GENERAL ELECTRIC SUPPLY CORP.

RADIO
BULLETIN No. 48-147

TELEVISION SERVICE BULLETIN

SUBJECT: TELEVISION SERVICE SUGGESTIONS

STRING TUNING DRIVE, MODEL 810.

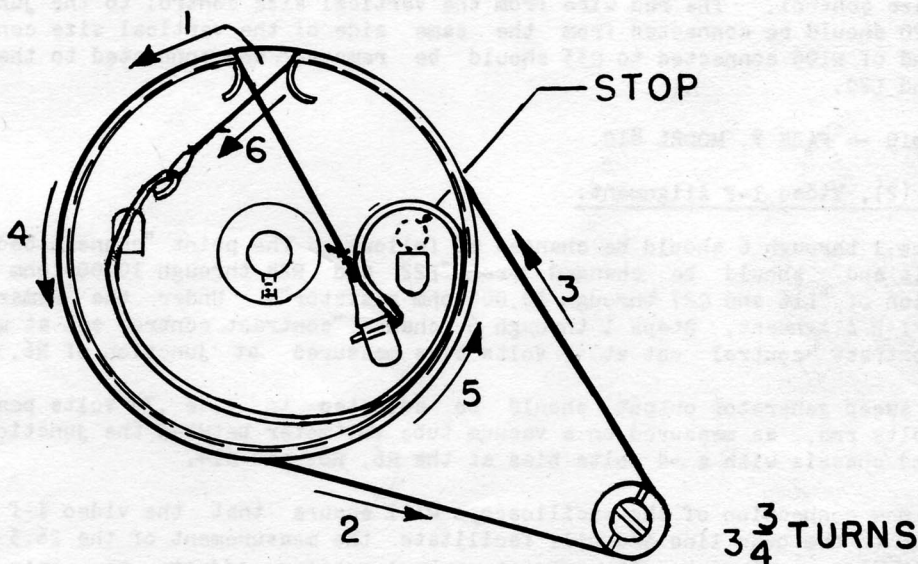
The tuning control on the Model 810 has been changed from a rubber pulley friction drive to string drive. This was done to eliminate a small amount of backlash which resulted in complaints of critical tuning adjustment when operating on the high frequency channels.

When making this change-over, it is necessary to remove and discard the rubber tuning control pulley, the tuning drum, and the knurled tuning control concentric shaft.

The following new parts are necessary to make this change, and are assembled as shown in the figure:

1	Tuning Shaft	Cat. No. RMU-048	\$0.25
1	Pulley and Hub Assembly	Cat. No. RMW-045	.45
1	Cord Tension Spring	Cat. No. RMS-118	.10
	Dial Cord	Cat. No. RDC-032	\$2.50/25 yd.
